**DRAFT- DOH Review:**  
**Navy Groundwater Flow Models & Related Issues with**  
**the Navy CSM for the Red Hill Facility**

*The Department of Health Hawaii (DOH)*  
*Technical subject matter experts*  
*Robert Whittier, Don Thomas, G.D. Beckett & Anay Shende*

*October 19, 2021*

# Local Water Levels

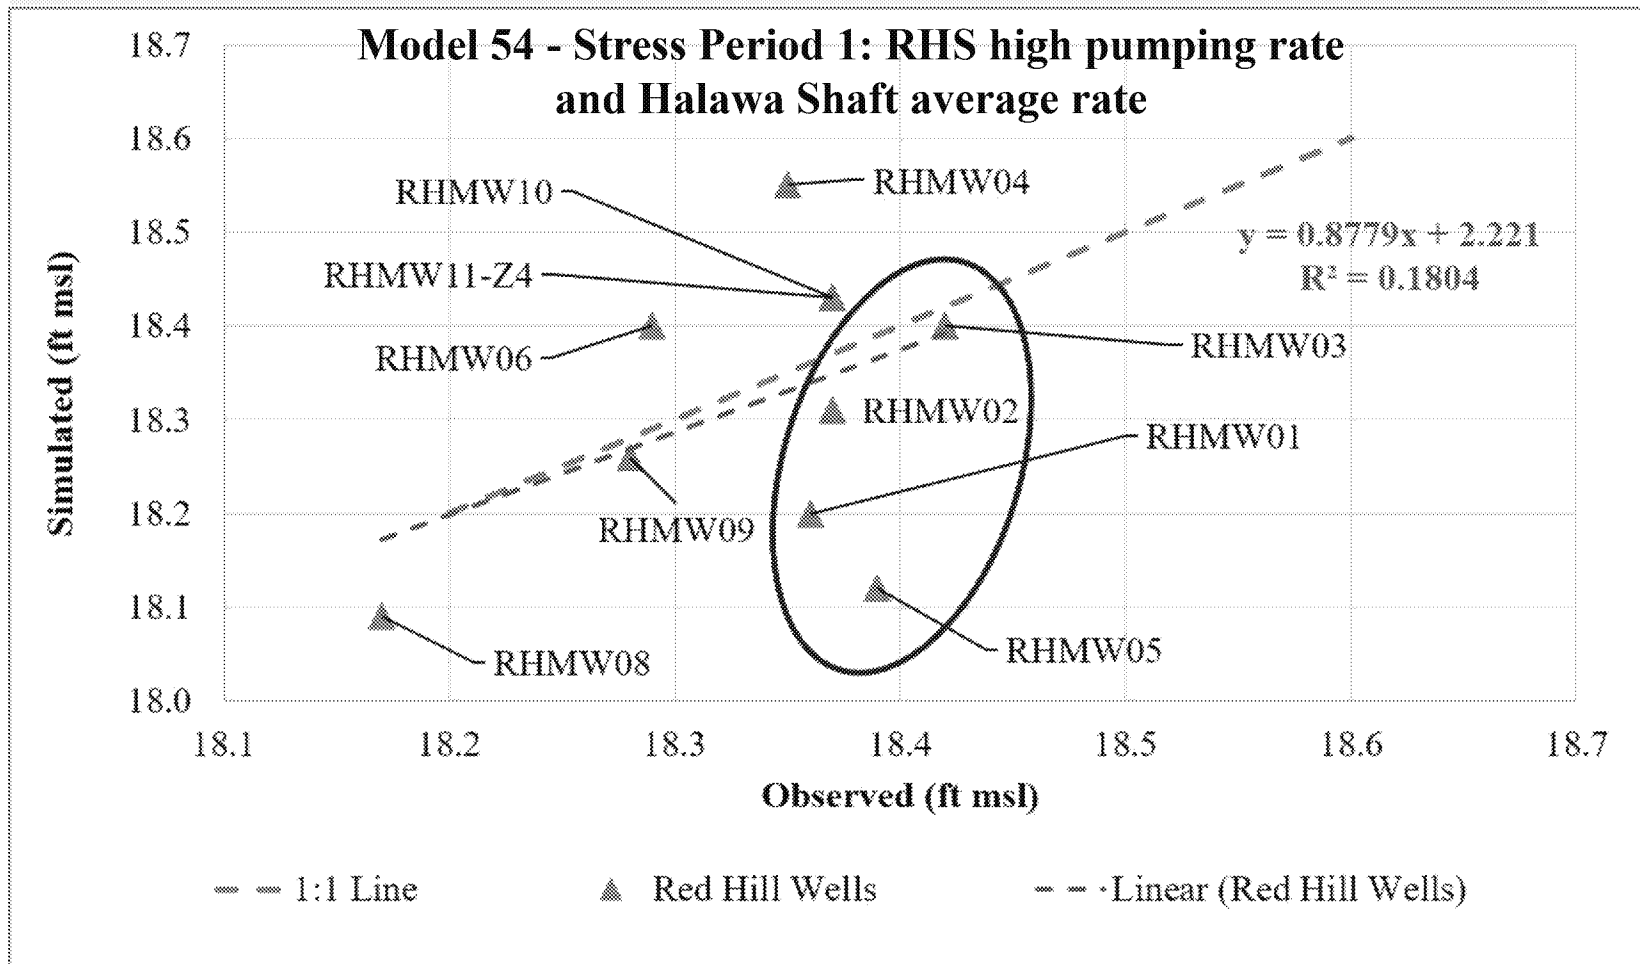
*(Navy GWFMs do not match local data)*

# Measured vs. Modeled RH Ridge Gradients

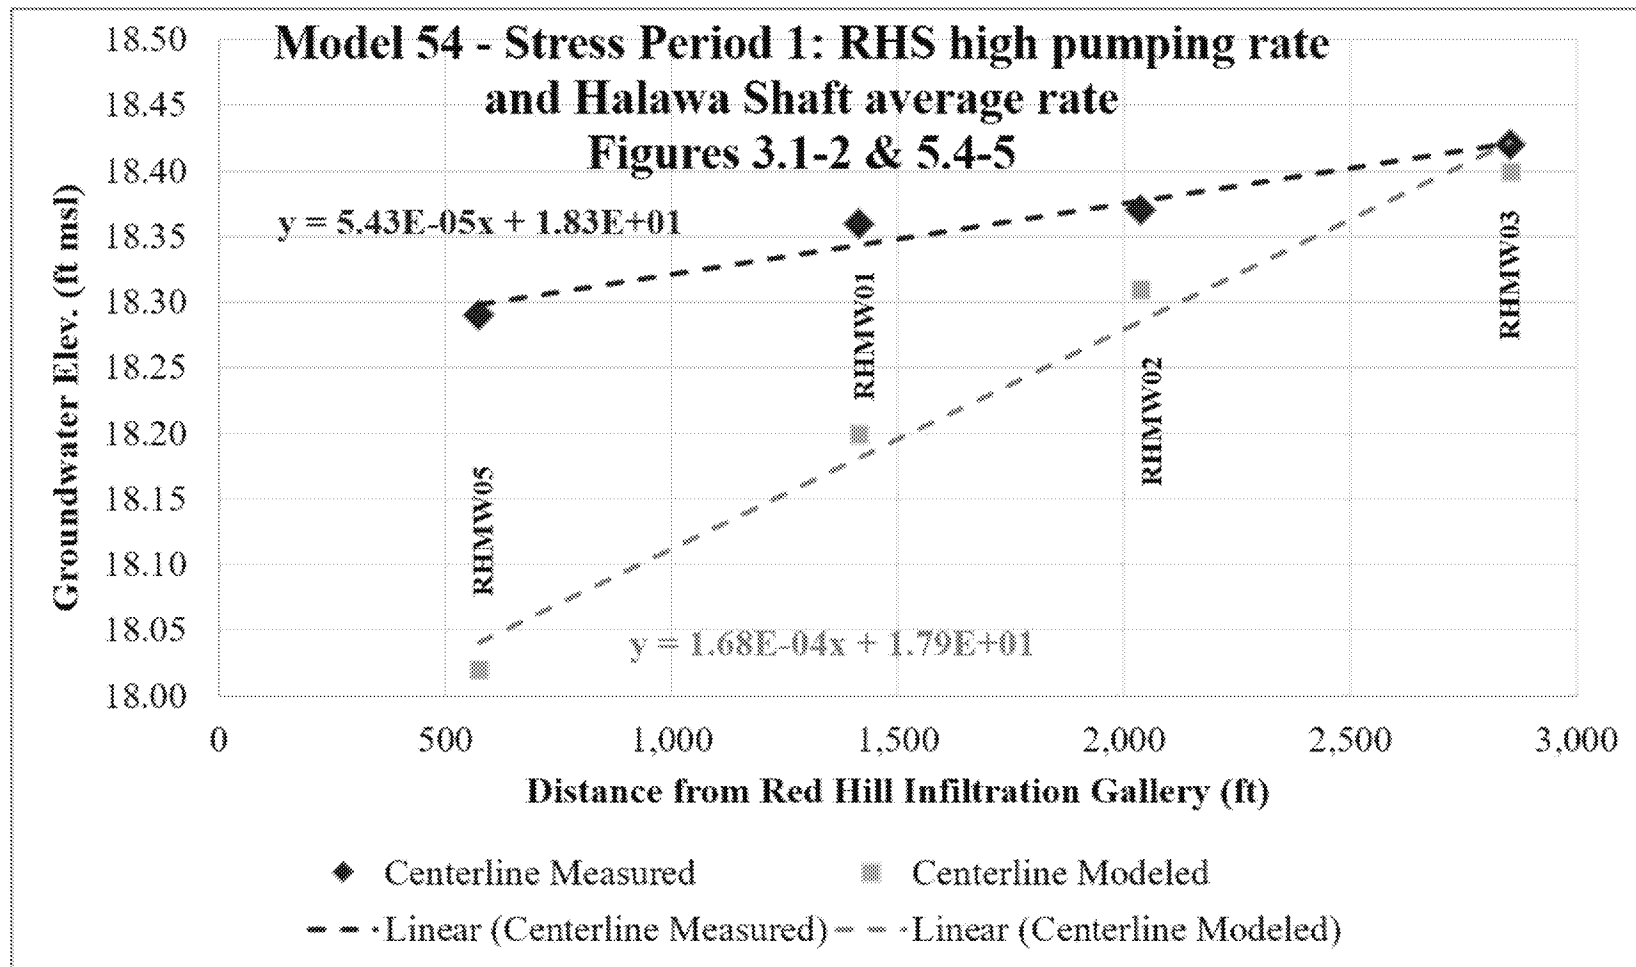
*(Gradient beneath and downslope of the tanks)*

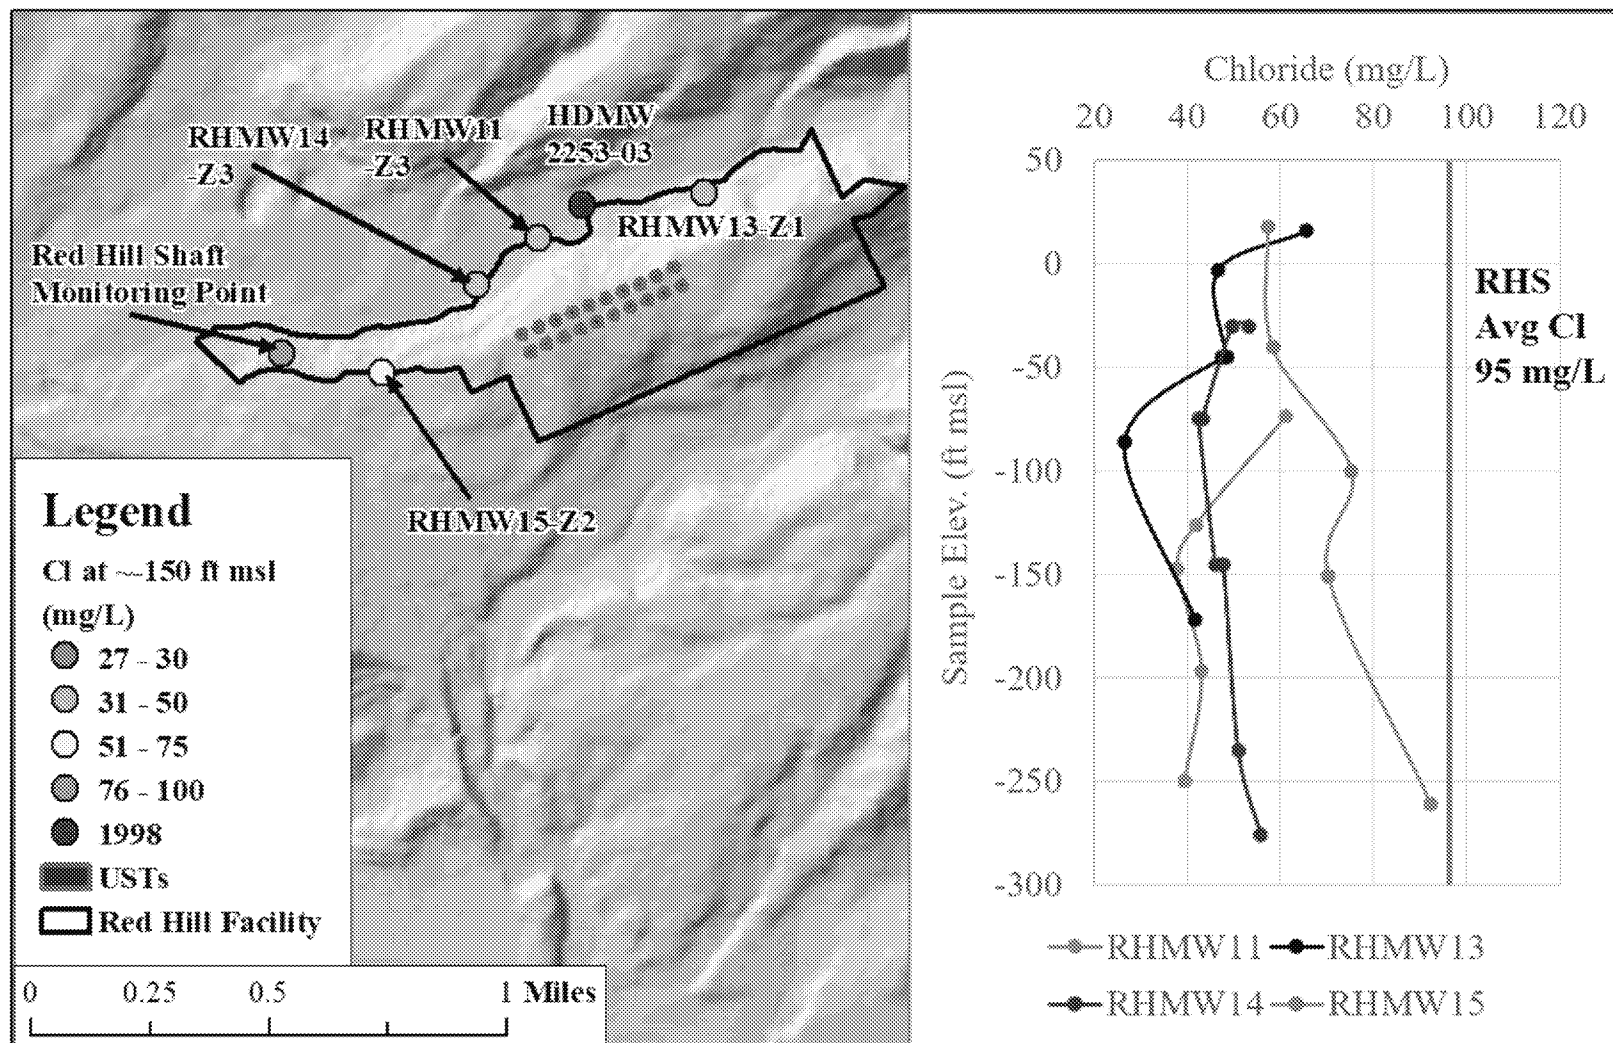
It is unlikely that chlorides originating in the Halawa region elevated the chloride concentration in the RHS

Figure 5.6-7, Redacted GWFM Rept, Mar 2020

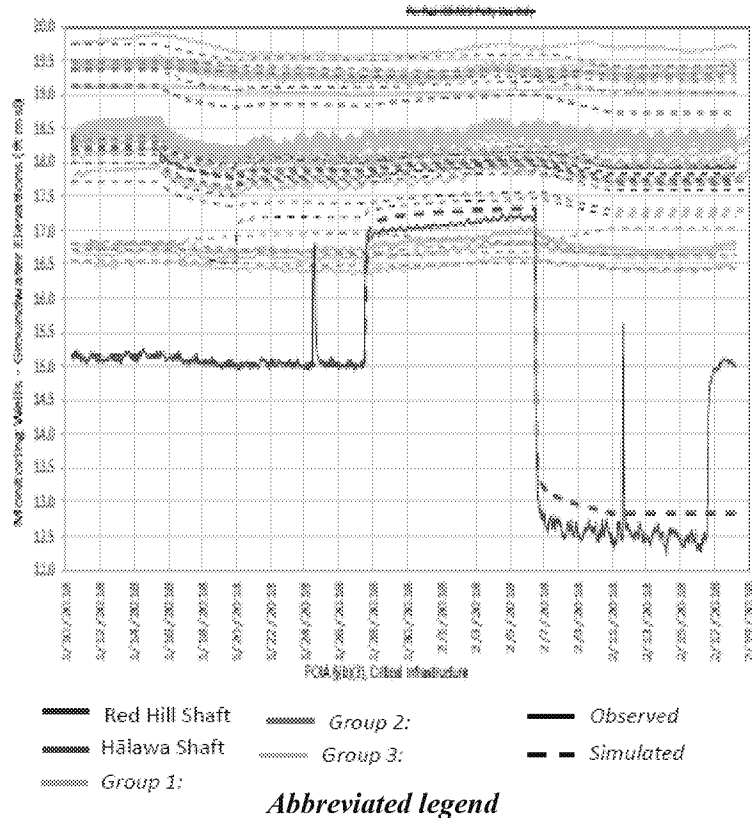
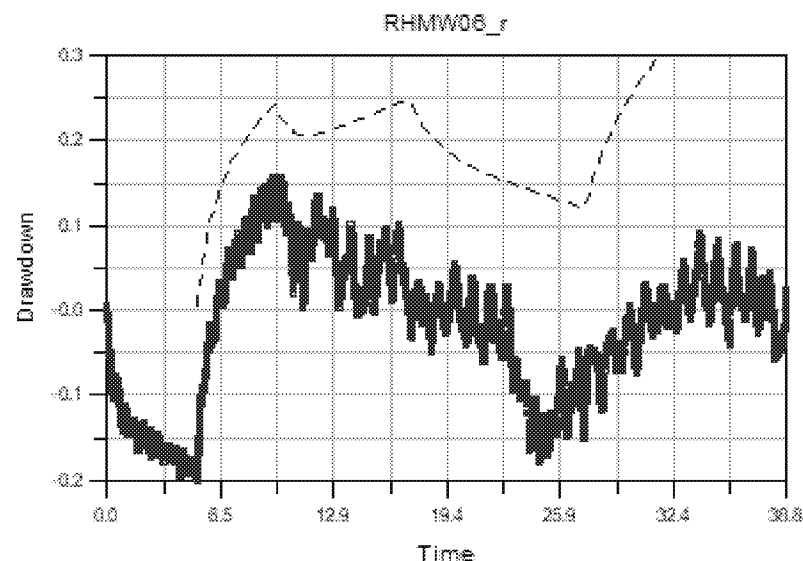
- Verification means just that
  - A “blind” test of the GWFM's predictions
  - How well do they agree with elevation data?
- How is this typically implemented?
  - Calibrate main models
  - Run against site data from another time
  - See how well each model reflects the data
- Purpose
  - Identify deficiencies in main models
  - Identify which are “best fits”
  - Consider transient implications
  - Consider compartmental responses (& others)
- Issue, we cannot replicate the reported results
  - Plots do not agree with modeled output
  - May be a superposition (drawdown upon measured)
- The g.w. elevation offset was prior model issue
  - Recall primary AOC objective

# Non-Uniform Distance Drawdown Behavior

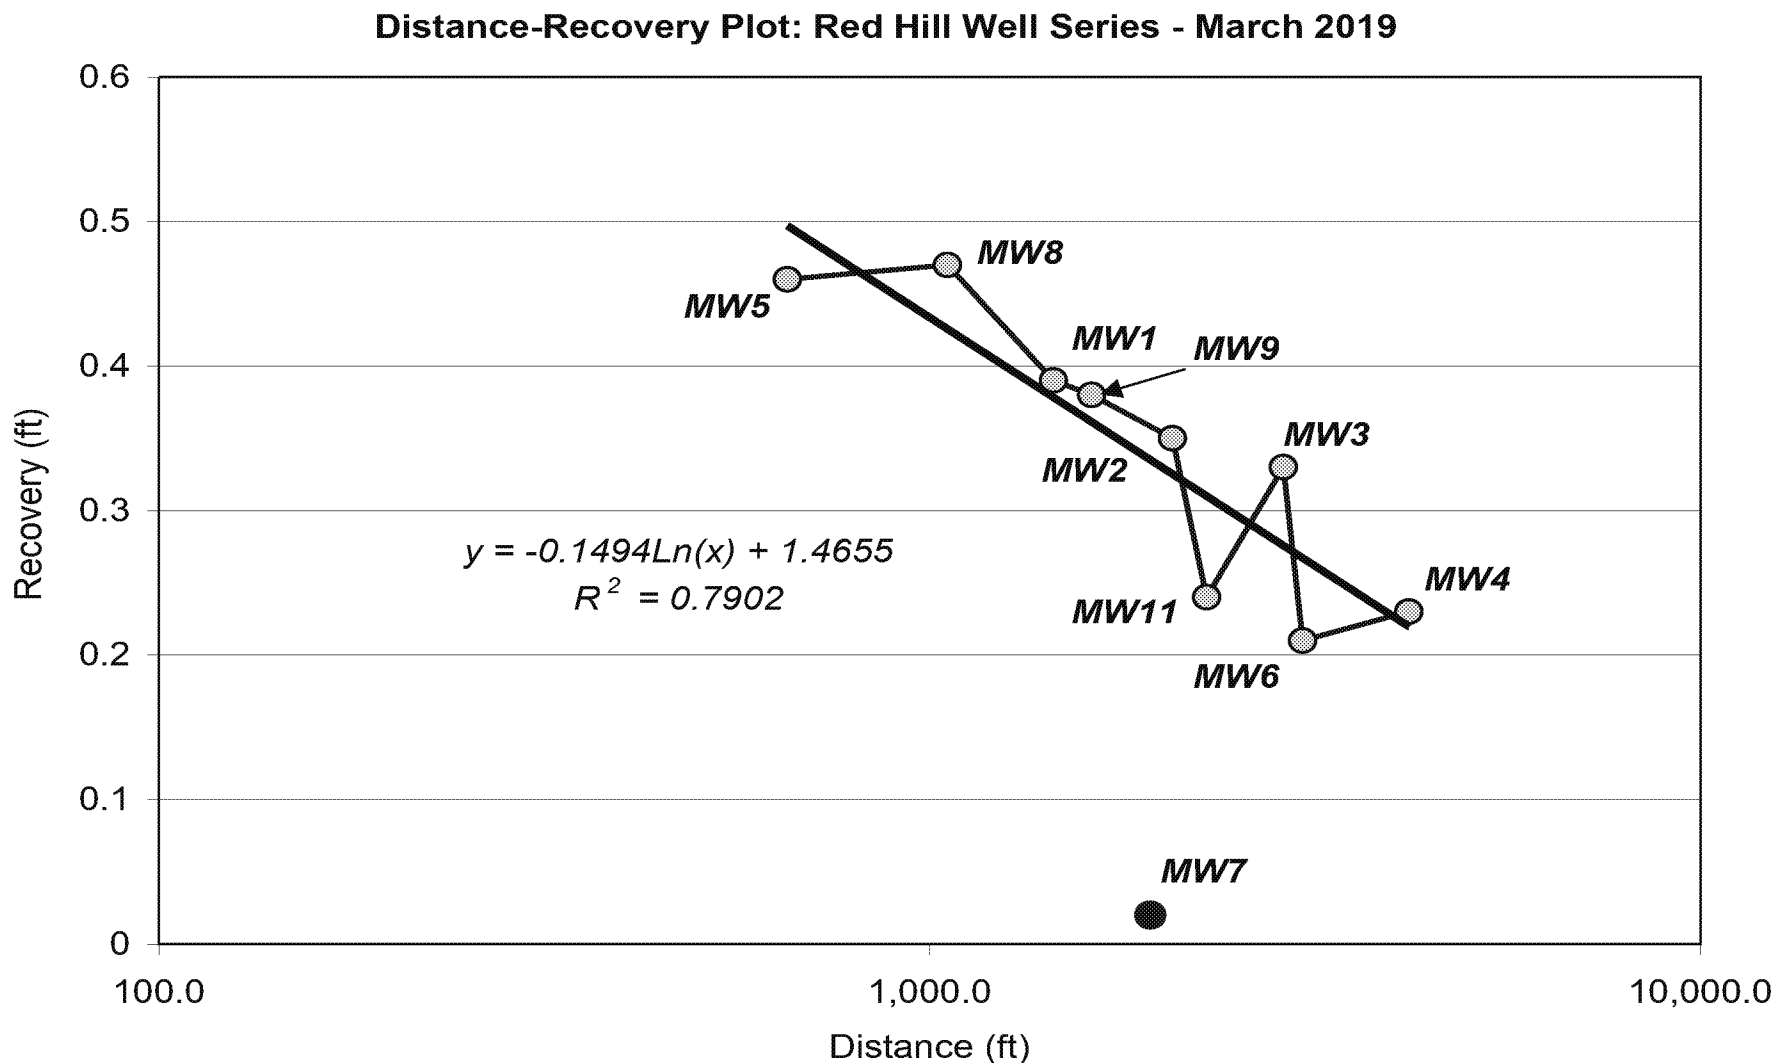
*(indicates complexities not captured by models)*

# Navy 3D Lithologic Model – Barrel Logs

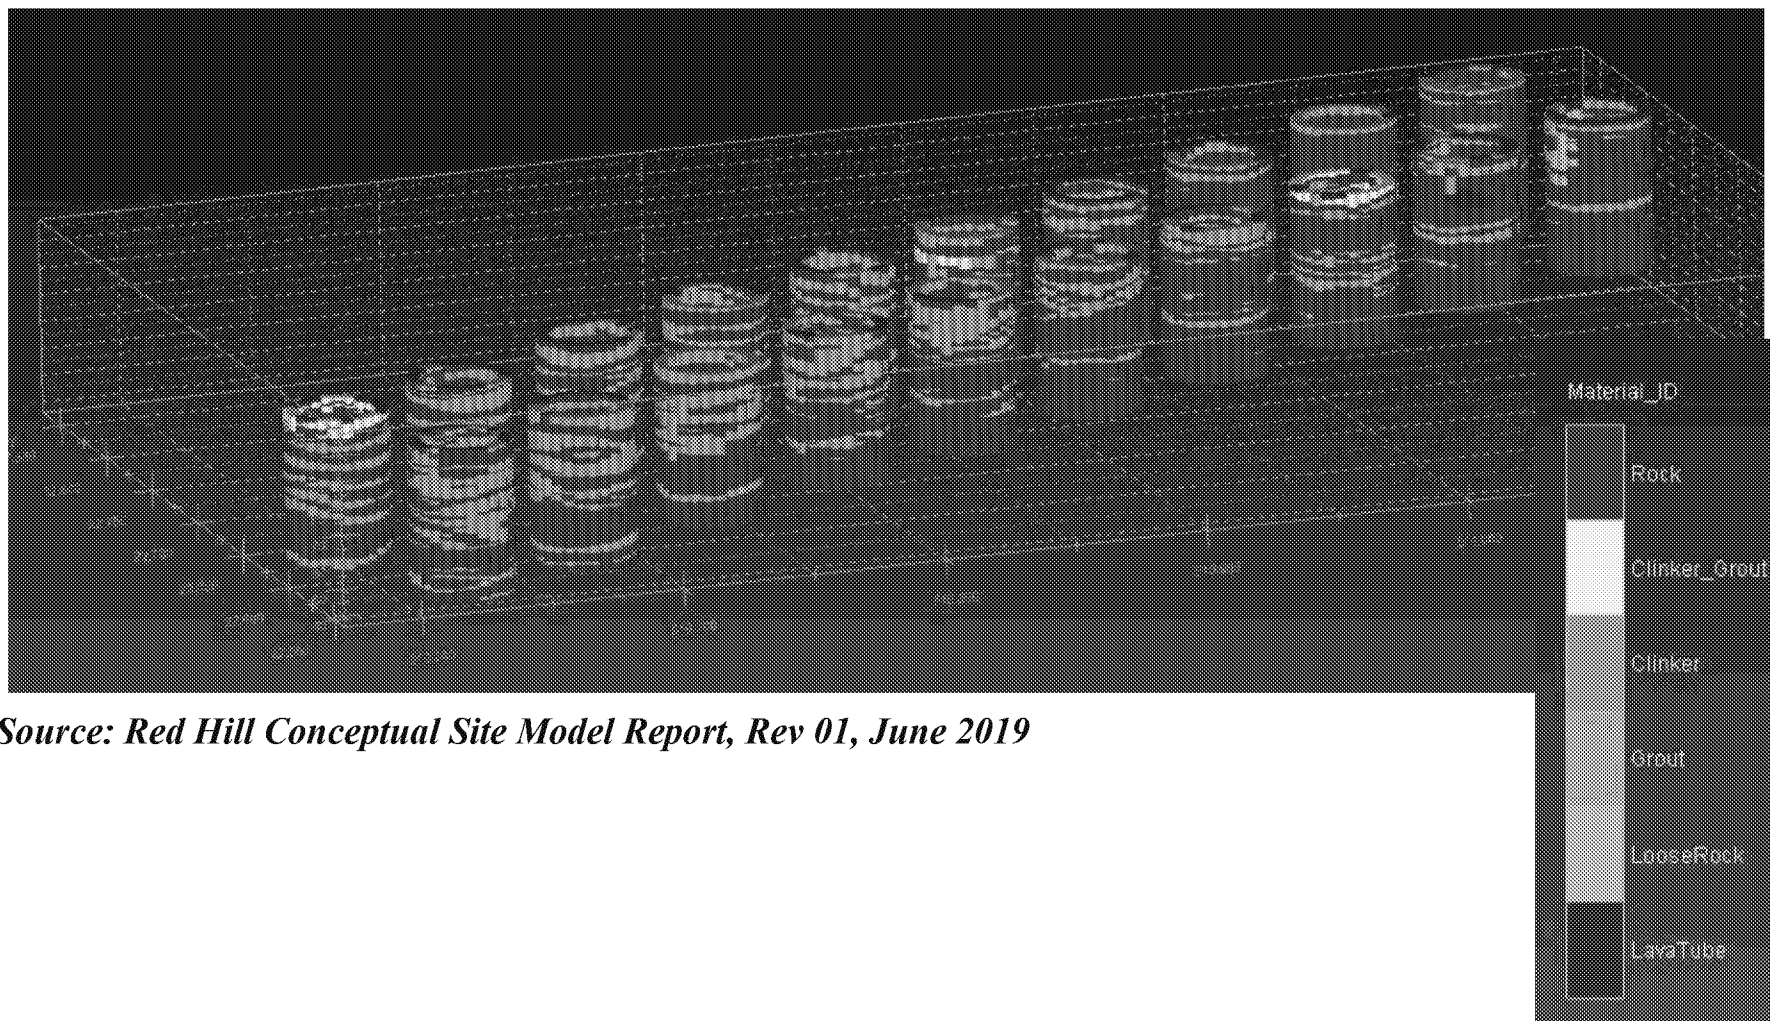
*(same issue, Dr. Tonkin will address)*
